**From:** Mess, Camie  
**Sent:** Friday, January 26, 2018 4:30 PM  
**To:** jmullen@rothjackson.com  
**Subject:** BAR Action- January 17, 2018 - 501 West Main Street

BAR 16-09-01  
425, 501, and 503 West Main Street  
Tax Parcel 320175000, 320176000, and 320177000  
Quirk Charlottesville, LLC, Owner/ Jennifer D. Mullen, Esq., Applicant  
New Construction: Final Details

Board of Architectural Review  
*Design Updates from October 16, 2017 Meeting*  
16 January 2018

EAST ELEVATION : PREVIOUSLY APPROVED

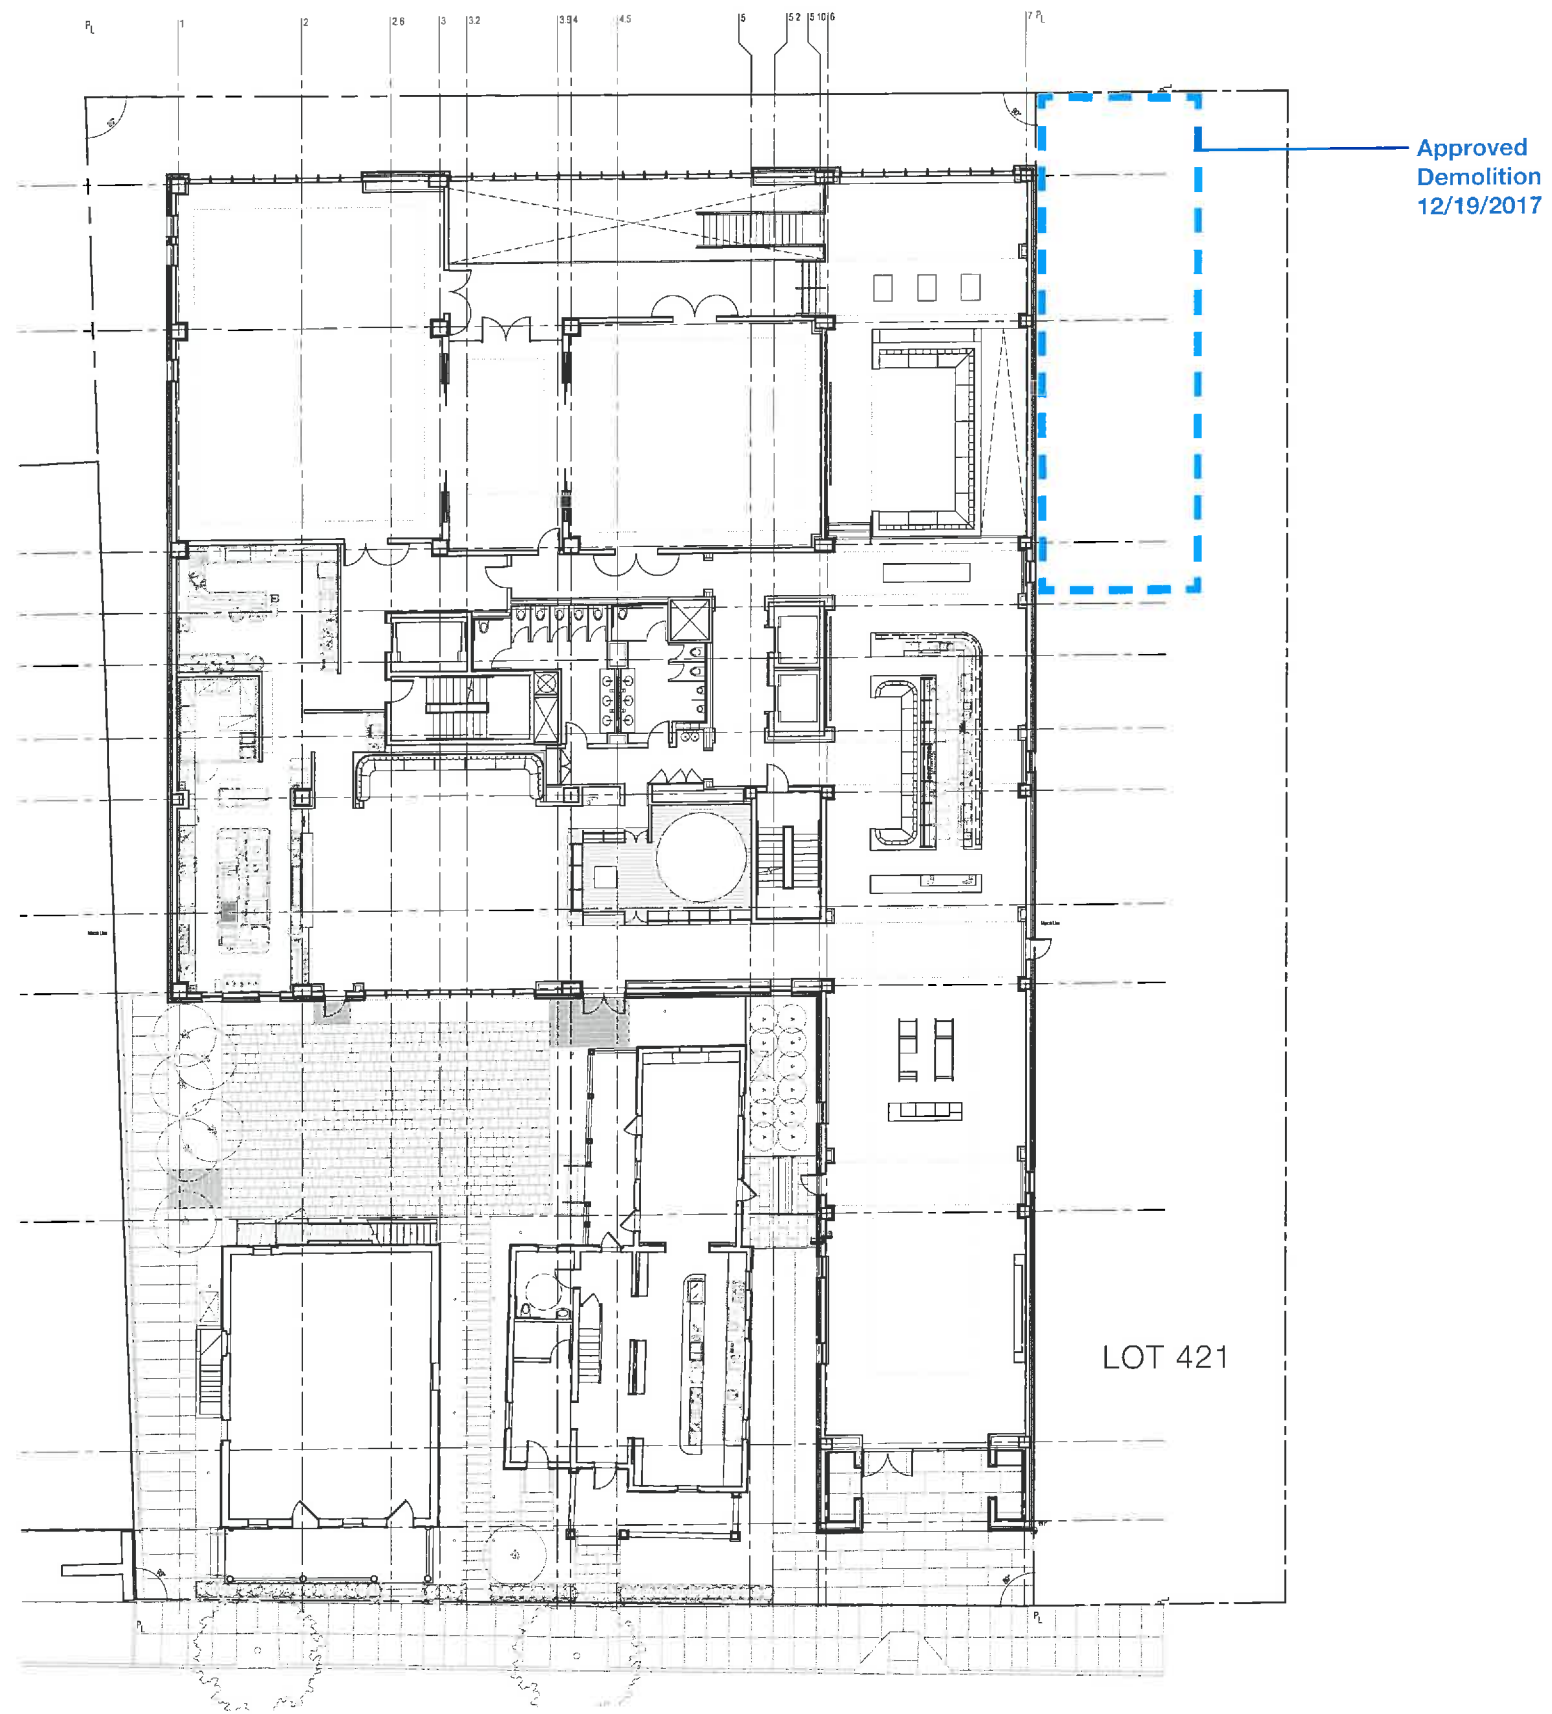
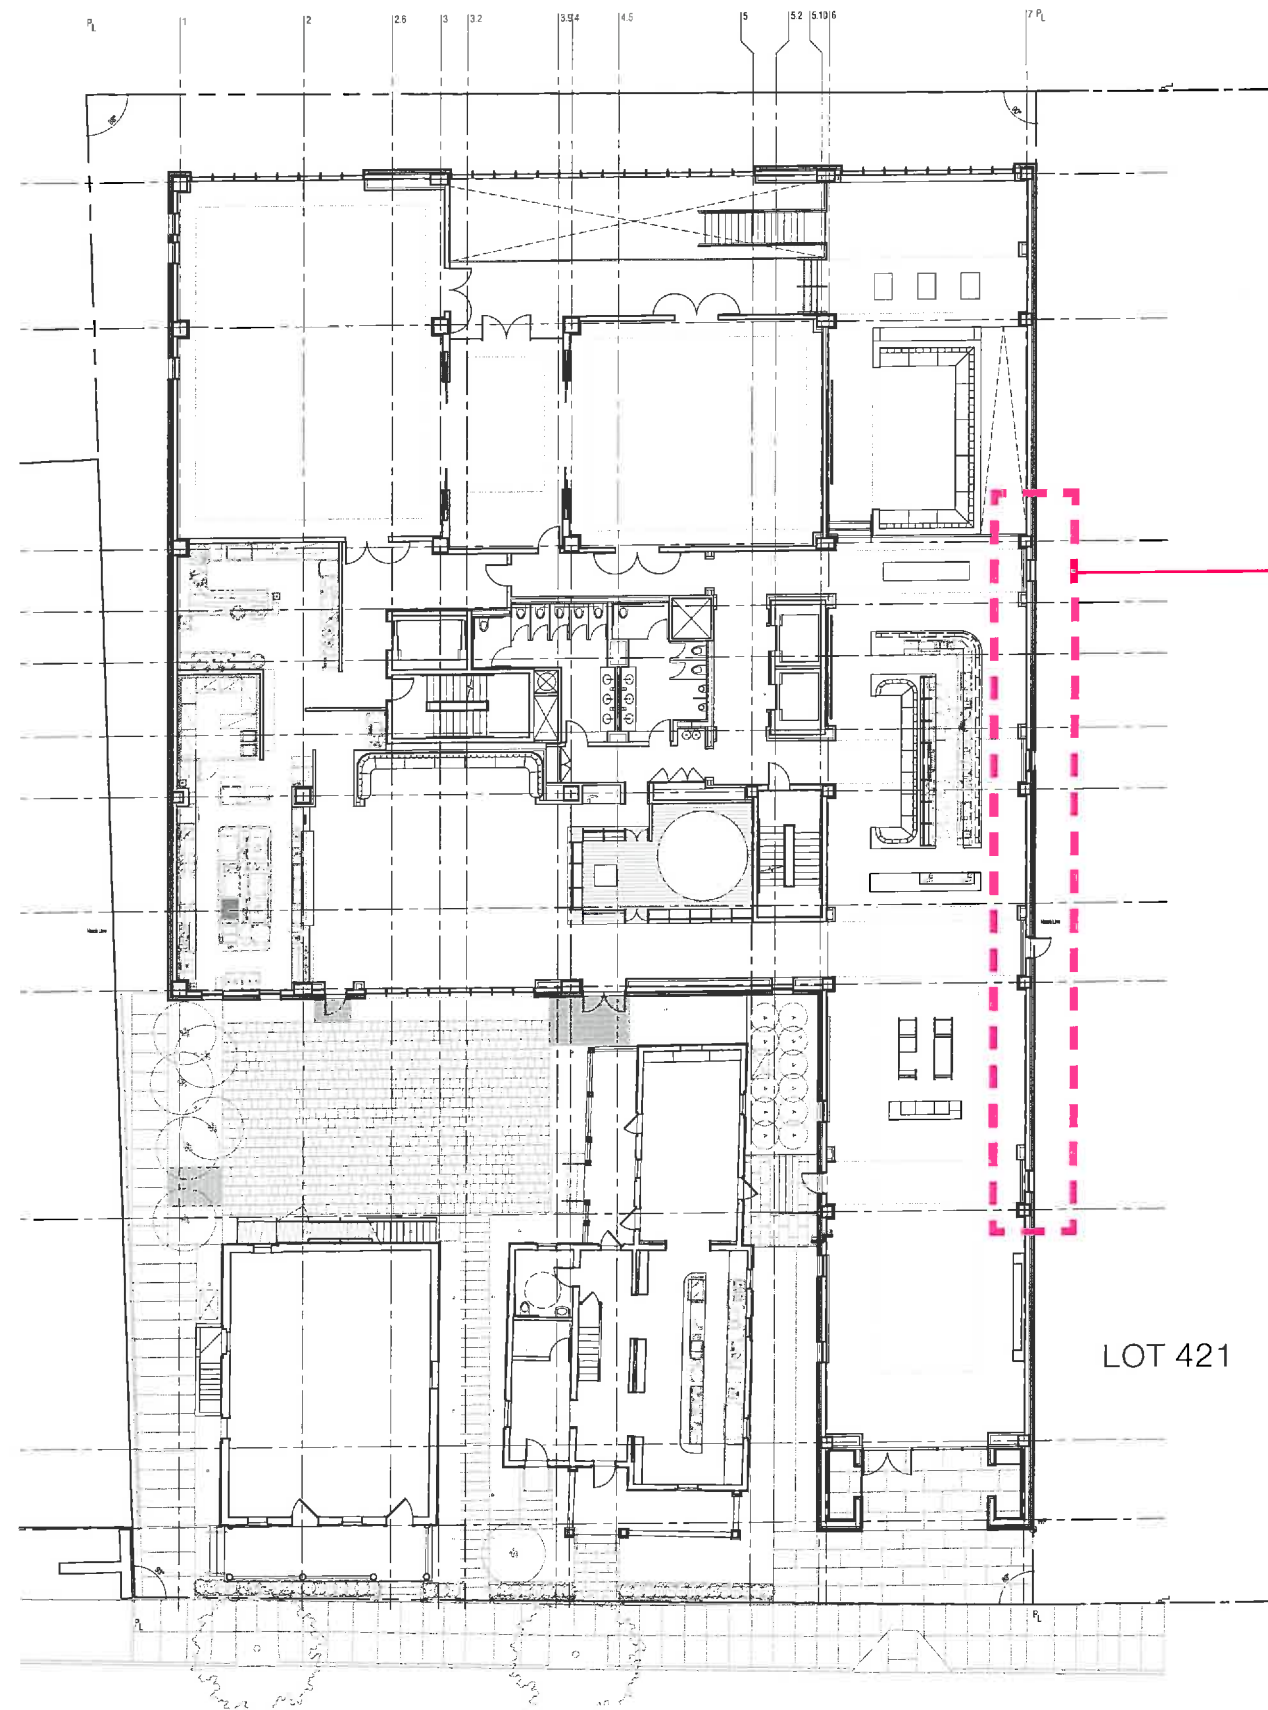
New window locations at  
hotel lobby  
(Permitted with demolition  
of Lot 421 building)

## Area-4, Porch Addition

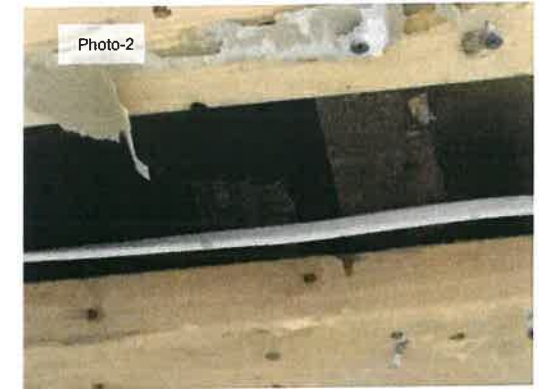
This structure appears to be an enclosure of an existing covered porch and stair or an entirely separate structure. Unlike the rest of the structure it is a wood framed and clad addition. We noted the highest degree of deterioration at this portion of the structure.

The deterioration is a result of poor initial construction, wood rot, differed maintenance and water washing through the mortar joints. There is also cracking at the masonry foundation wall at the joint of this structure.

The proposed selective demolition can be carried out without structural ill effect to the existing original structures. In the case of the porch addition the removal will have a beneficiary effect on the portion of the structure to remain.

PREVIOUSLY APPROVED STAIR :  
REQUIRED ADDITIONAL STEEL STRUCTURE  
WITHIN EXISTING BUILDING

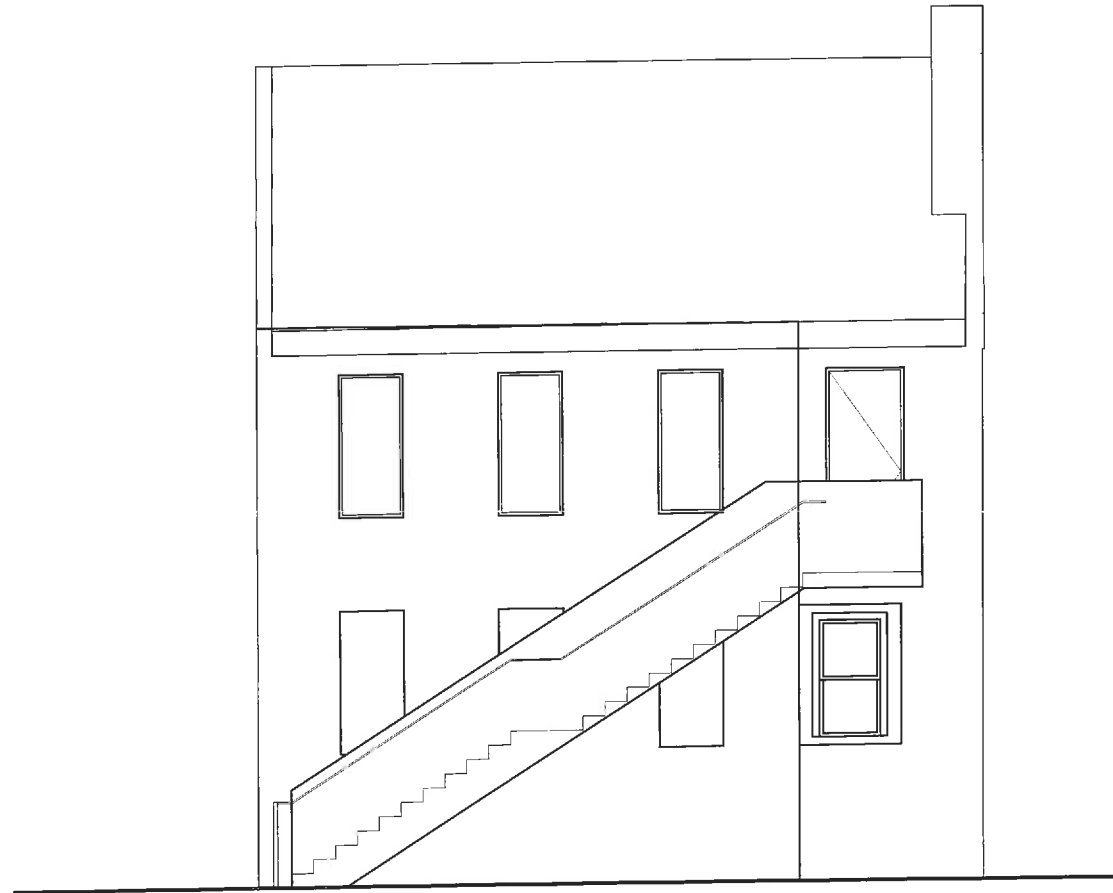
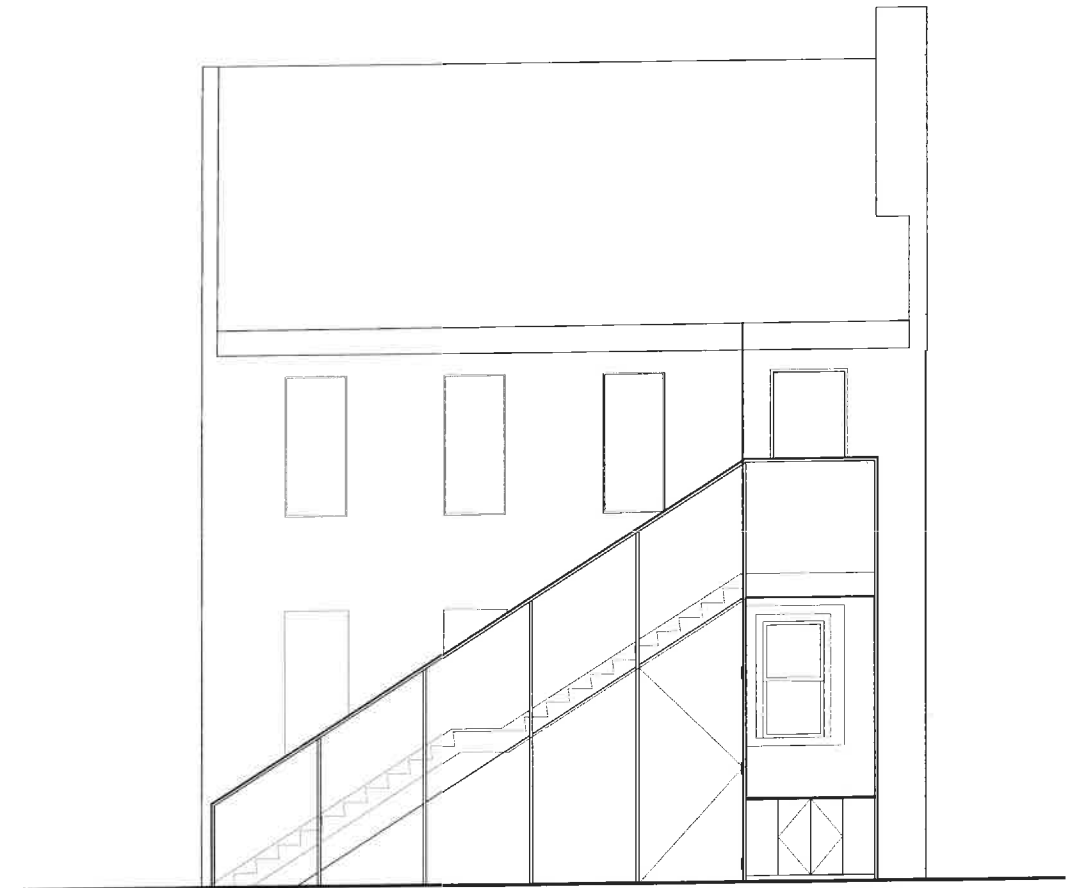
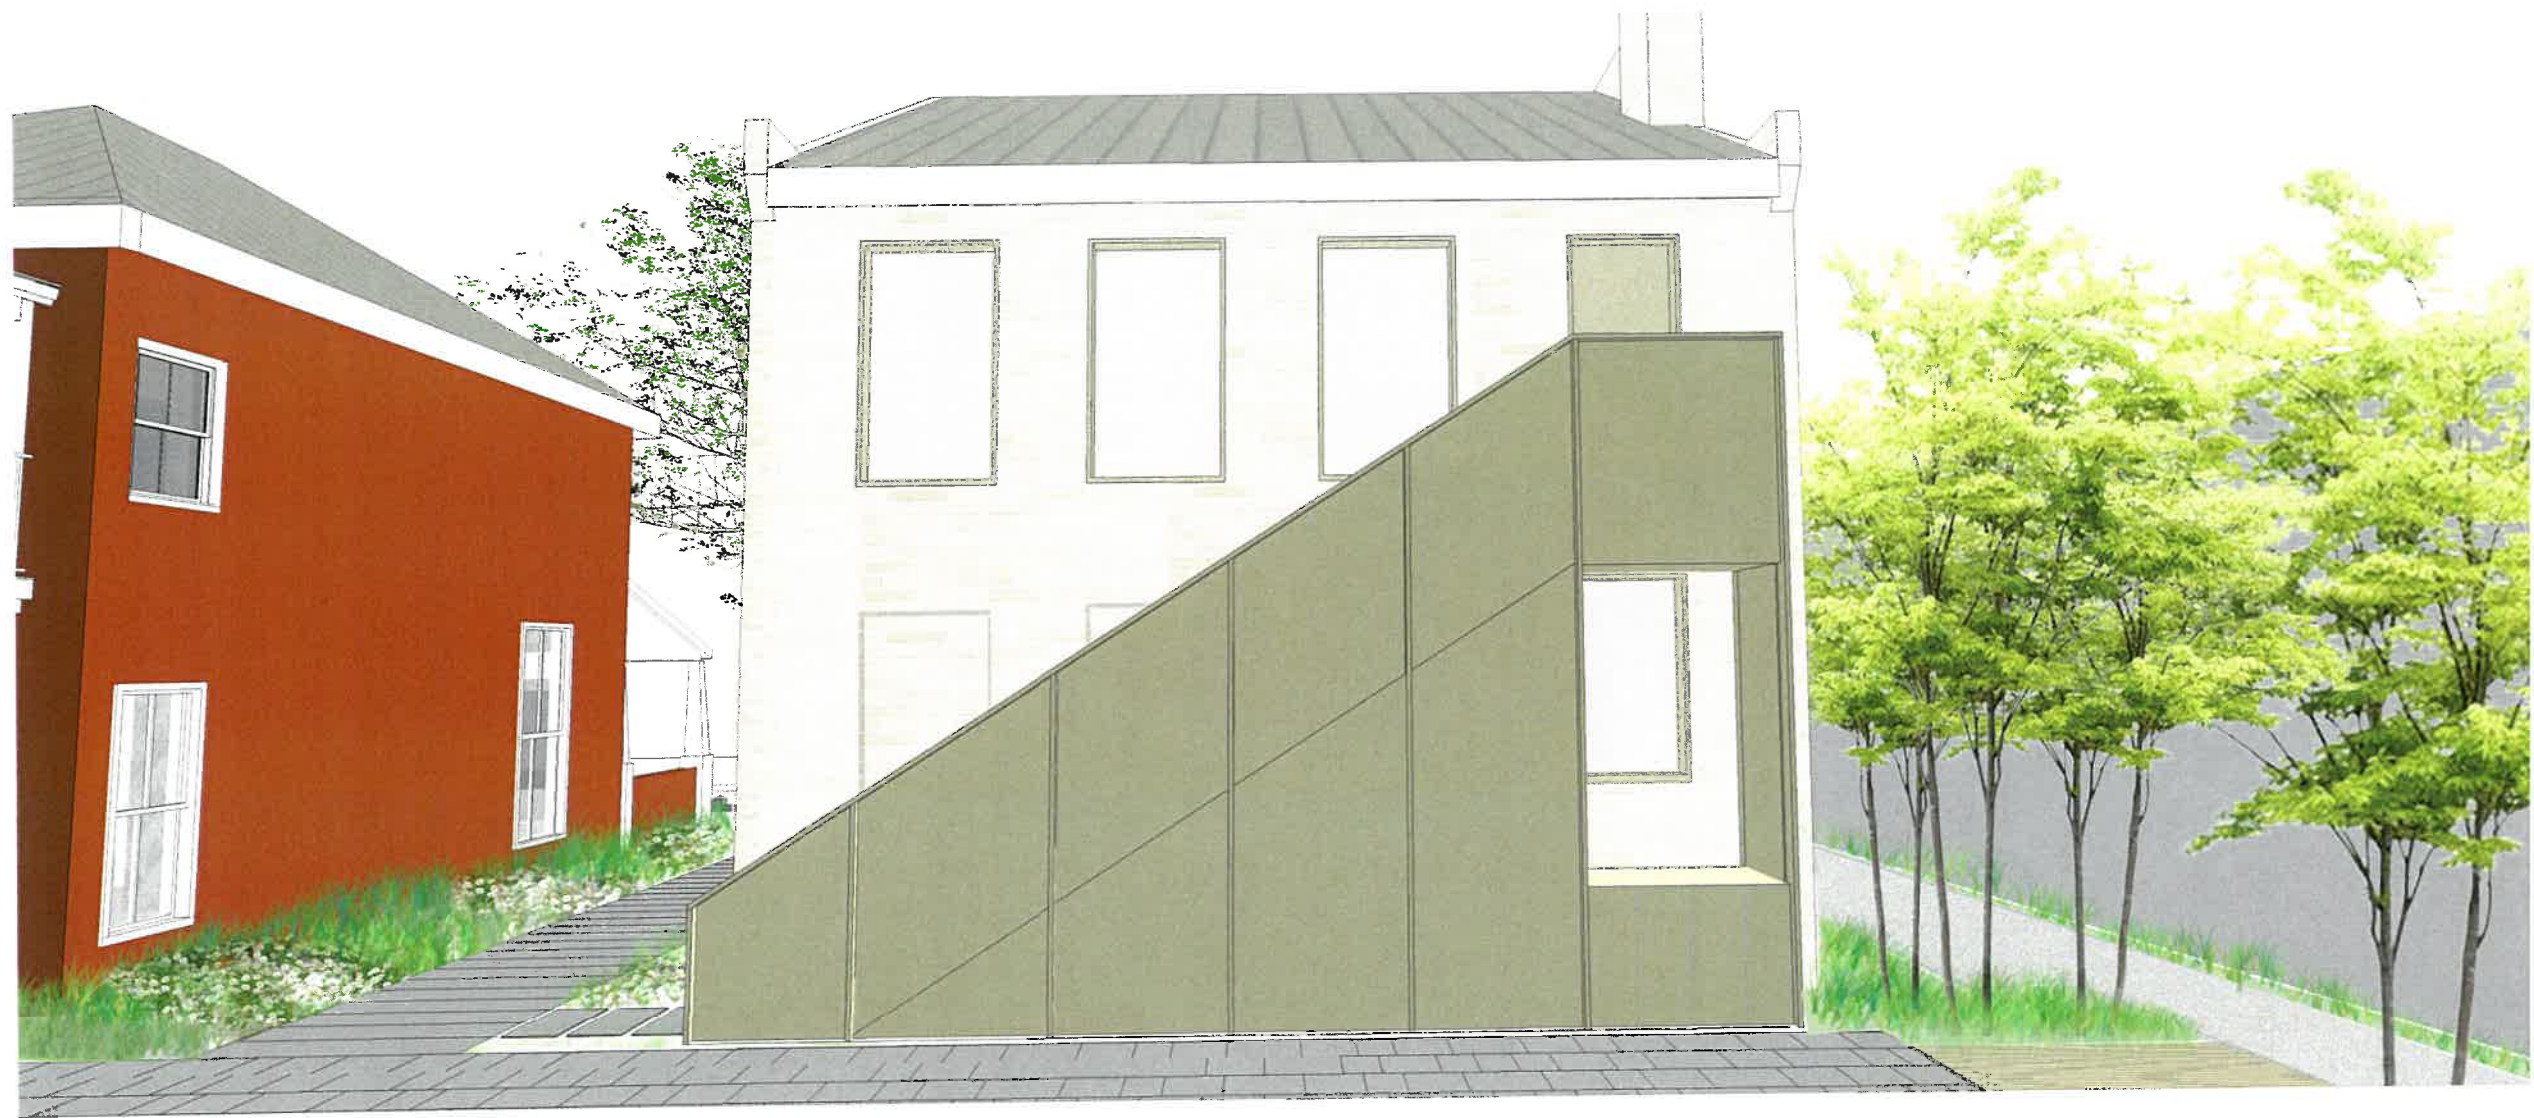
Beams cantilevered from  
Existing Building

Beams were to be  
supported by new columns  
within Existing Building

PROPOSED STAIR :  
FREE-STANDING
